Client	Mr Andrew Scott
Project Name	Oak Hill House, Upper Seagry
Report Title	Transport Technical Note
Report Ref.	TN01
Project No.	C25-182
Date	23/09/2025
Produced By:	RM

Transport Technical Note

- 1.1.1 This Transport Technical Note (TN) has been prepared by Apex Transport Planning ('Apex') on behalf of Mr Andrew Scott. It has been prepared in response to planning application (planning reference: PL2025/06615) which seeks permission for four flexible B8 storage or Class E commercial business units on land at Seagry House, Upper Seagry, Wiltshire.

Figure 2.1: Extract of drawing 23075-PHL-01C

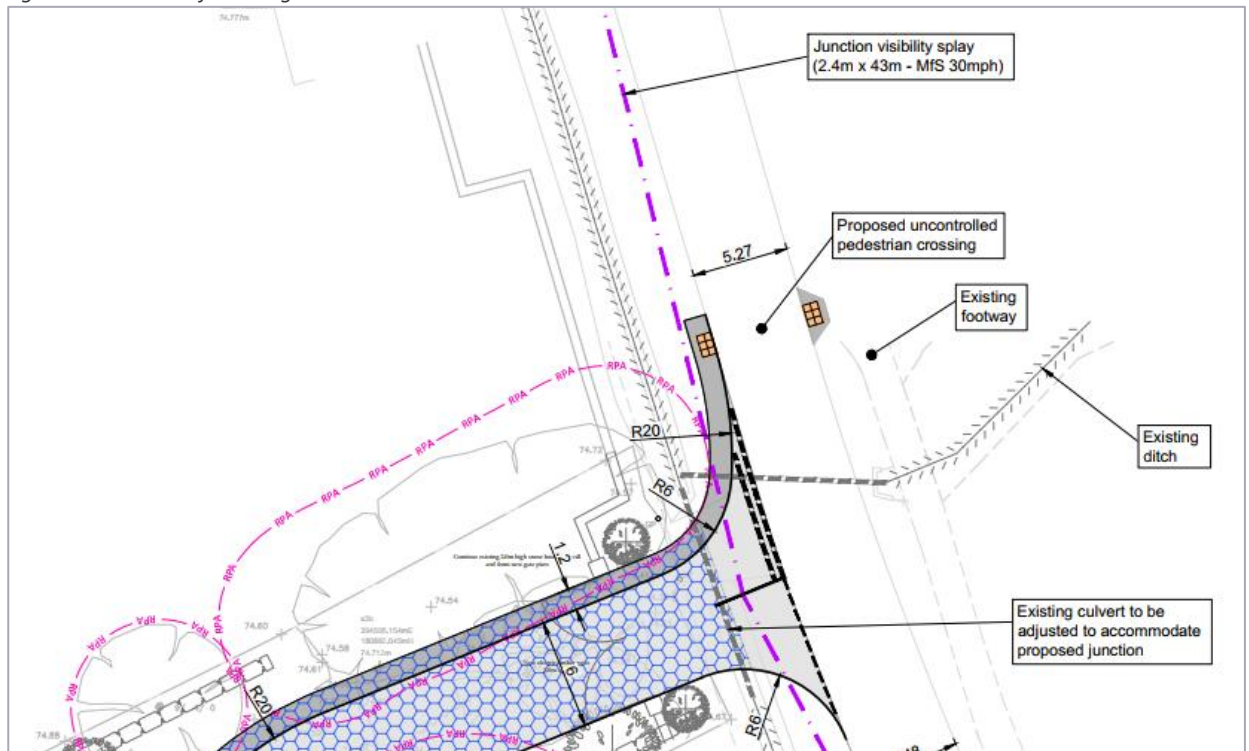
- 2.1.7 Whilst the visibility splays are shown for drivers exiting the access, the TS fails to consider the visibility splay requirements for pedestrians at the proposed dropped-kerb tactile paving crossing points. At these points, visibility splays of 1.5m x 43m are required, in accordance with the requirements of the

DfT document *Inclusive Mobility (December 2021)* and *CD 143 Visibility at junctions and crossings*. Furthermore, in accordance with MfS, the visibility splays should be free of obstacles above a height of 600mm.

Figure 2.2: Culvert post and rail fence - view taken 1.5m back at location of proposed crossing point

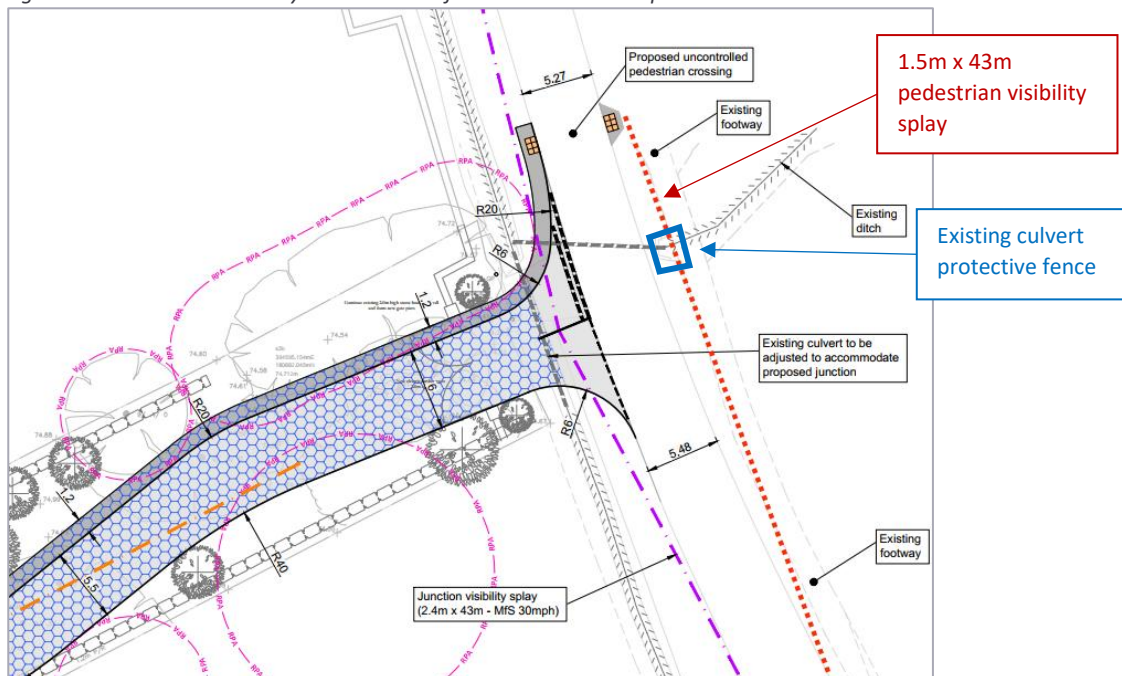
- 2.1.8 Opposite the proposed access junction and approximately 10m south of the eastern tactile paving is an open culvert which is protected by a timber post and rail fence. This presents a significant obstacle within the required visibility splay and exceeds the maximum height of 600mm.
- 2.1.9 Figure 2.2 presents the view looking south from the eastern crossing point, 1.5m from the kerb edge, and Figure 2.3 illustrates the height of the obstacle.

Figure 3.1: Extract from tree protection plan (source: Hillside Trees Ltd)

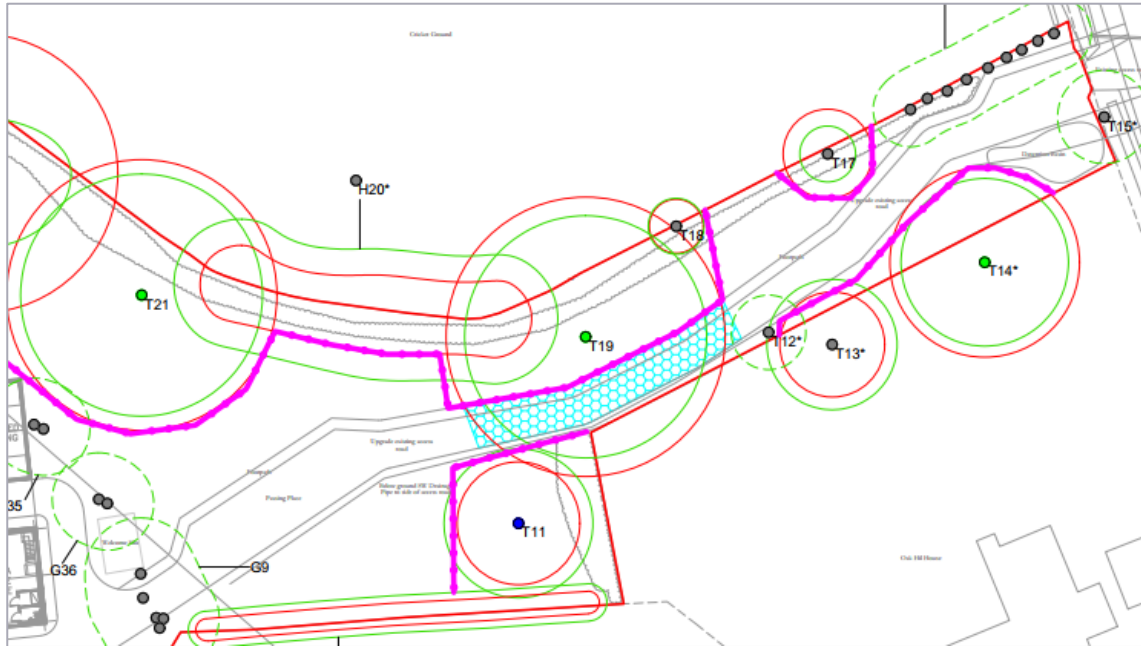
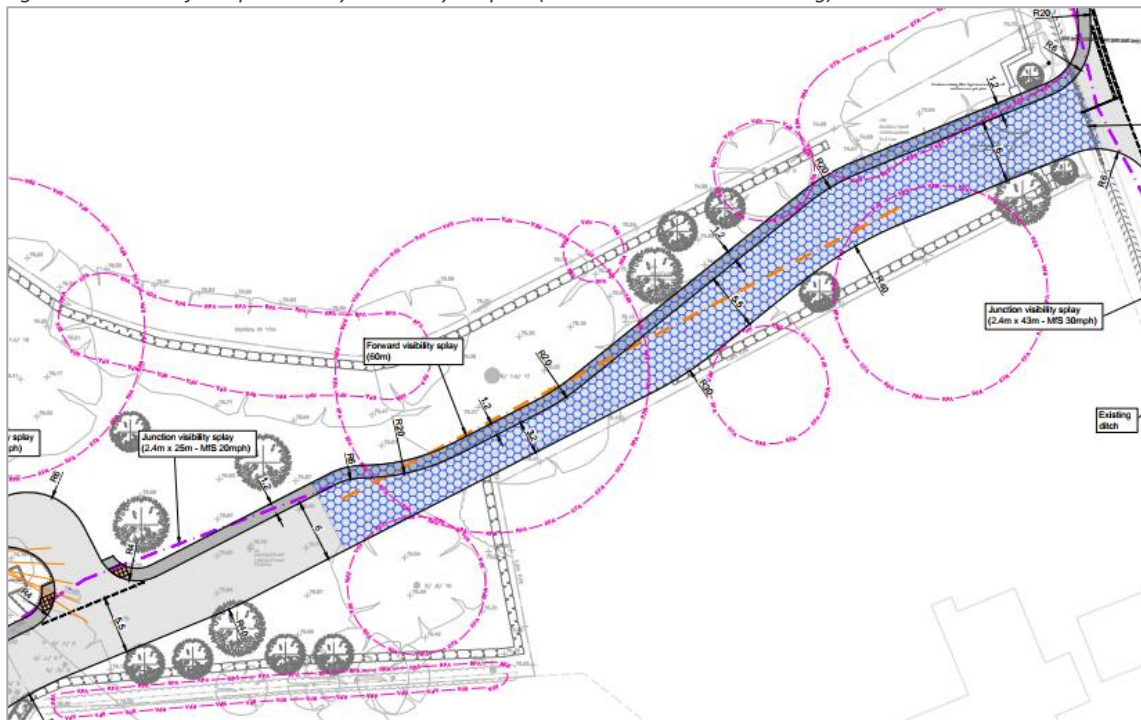
- 3.1.1 There is a discrepancy in the submitted information regarding the access road layout, with different layouts shown in the TS and that included within the Arboricultural Report on the tree protection plan prepared by Hillside Trees Ltd (plan reference: 250626-SH-Comm-TPP-NB). Both layouts are shown in Figure 3.1 Figure 3.2 respectively.

- 3.1.2 Presumably the proposed access road layout is the one included in the TS and as shown at Figure 3.2 – this should be clarified. Moreover, it is unclear whether this layout has been assessed by the Arboriculture consultant in respect of impacts upon the root protection area.

- 3.1.3 Moreover, GE Consulting has undertaken a review of the arboriculture report on behalf of our client, Mr Andrew Scott, and this has found significant concerns with the impacts of the access strategy upon the root protection area. Given these concerns, it is unclear whether the access road layout as shown in the TS will be deliverable in practice. It is therefore necessary that the arboriculture impacts are confirmed in order to assess whether the access strategy is suitable or not.
